SERVICE BULLETIN

TS-930S CW Pitch Tone Shift

7-06-83

SIDETONE MIXER

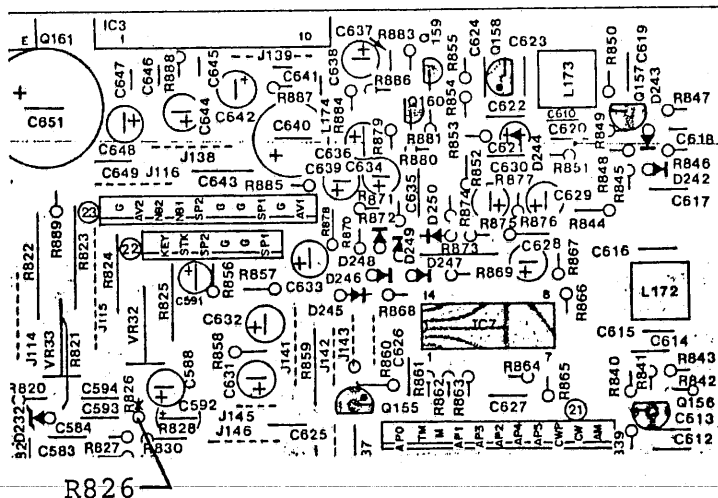
Some users of the TS-930S have reported a slight change in the CW pitch tone when the MONI switch is turned ON and OFF.

This may be corrected by changing the following components:

On the Signal Unit (X57-1000-XX) change R826 from a 1K ohm to a 10K ohm, part no. RD14CB2E103J and remove C601, a .022 μ F capacitor from the foil side of the circuit board.

Schematic address: F,8
